Department of Transportation

MEMORANDUM

SUBJECT: ZC Case No. 19-10 – The Lady Bird

Figure 1 – Site Plan (Source: CTR, Gorove/Slade, Figure 7, 8/23/19)

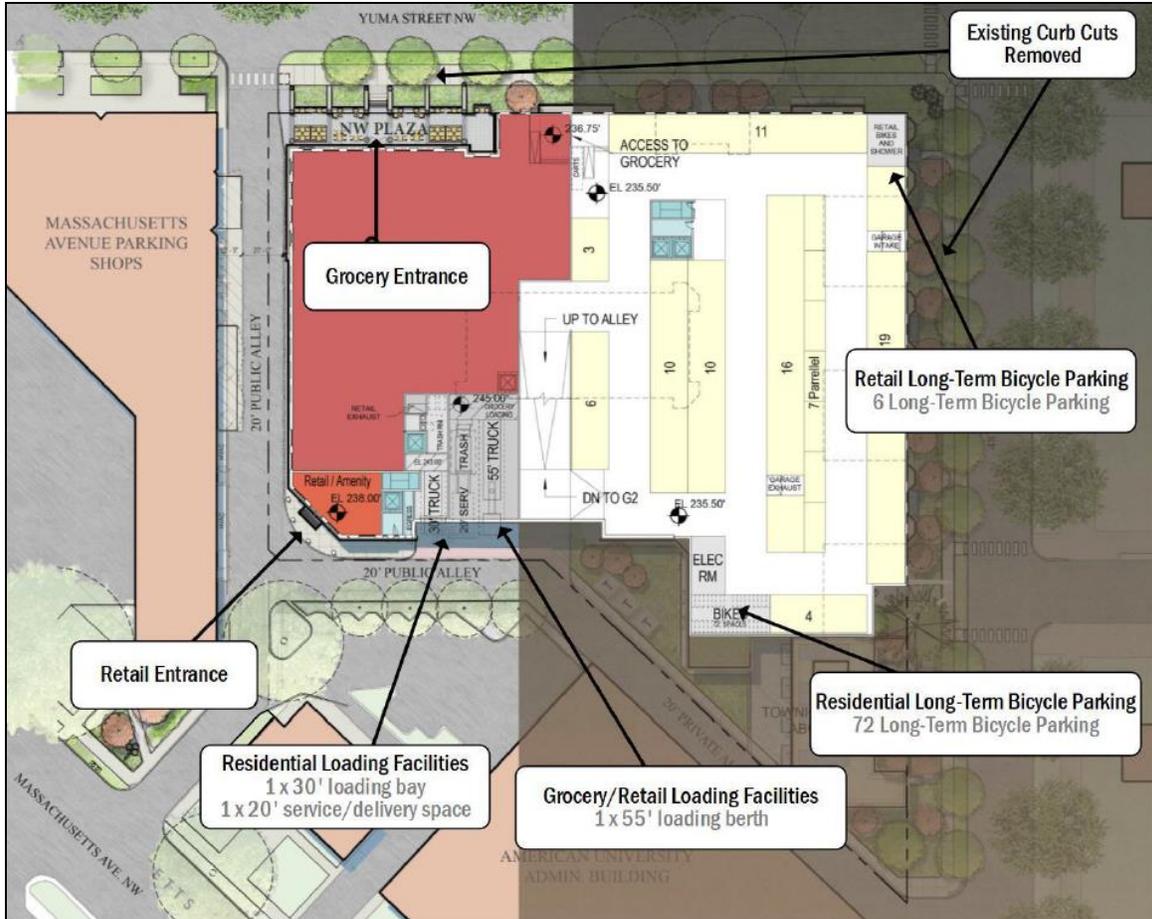
While the preliminary public space plans, shown above in Figure 1, are generally consistent with DDOT standards, there are several considerations that need to be reviewed in greater detail during the public space permitting process:

- DDOT concurs that the existing curb cuts on Yuma Street and 48th Street NW should be closed and replaced with green space and street trees;
- An occupancy permit will be required for any portion of the outdoor café in public space near the Yuma Street NW grocery store entrance;

- Building projections on Yuma Street NW should not project more than 4-feet into public space;
- The concrete strips running north-south in the middle of the green space near the grocery store entrance on Yuma Street NW should be removed;

- DDOT finds the design of the proposed trash enclosures along the public alley appropriate and will require a public space occupancy permit;
- All dumpsters currently located in public space along Yuma Street west of the alley and east of Exxon, which is within the DDOT right-of-way, should be moved to the new enclosures in the public alley; and

- There are several sections of pavement in public space along Yuma Street west of the alley and east of Exxon, within the PUD area. These areas should be restored to green space with leadwalks connecting from the sidewalk to building entrances.

Figure 3 – Proposed Pedestrian Improvements (Source: CTR, Gorove/Slade, Figure 13, 8/23/19)

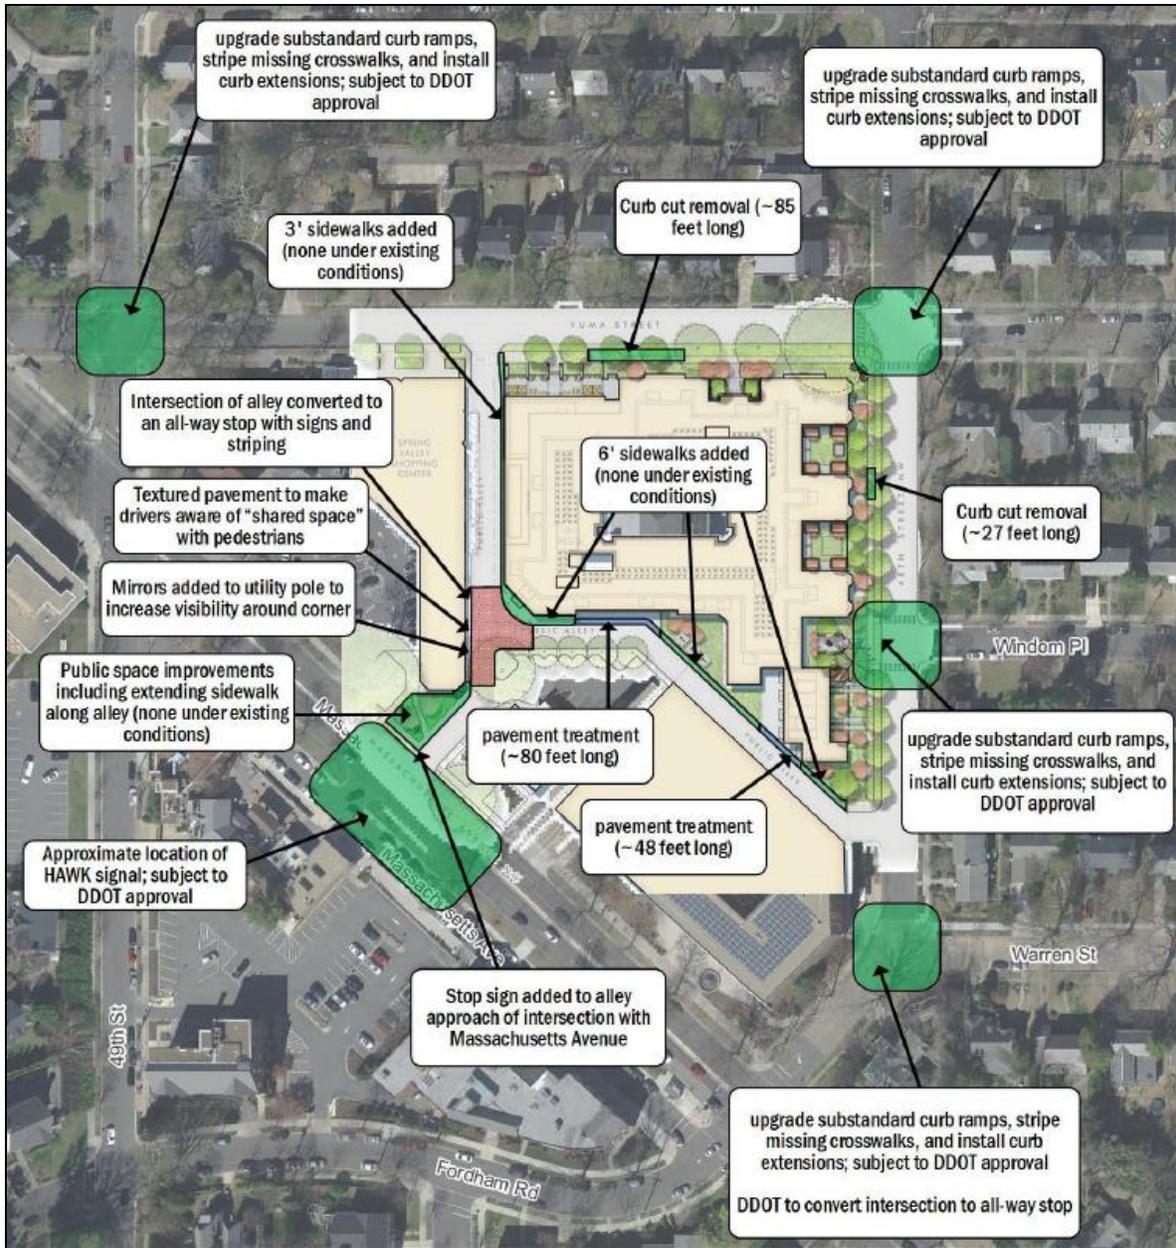
As discussed previously in the Vehicle Parking section, to offset the potential induced demand for being over-parked, the Applicant has agreed to fund and construct several pedestrian network improvements in the immediate vicinity of the site to encourage walking and discourage driving. Specifically, the Applicant will upgrade sub-standard curb ramps, stripe missing crosswalks, and install curb extensions on all corners of the following intersections, subject to DDOT approval. These curb extensions will make the stop signs more visible to drivers, shorten the crossing distance for pedestrians, and slow turning vehicles.

In conjunction with a robust TDM program, DDOT finds these intersection improvements to be acceptable and appropriate mitigation. DDOT notes that the final design of the curb extensions, curb ramps, and crosswalks will occur during public space permitting.
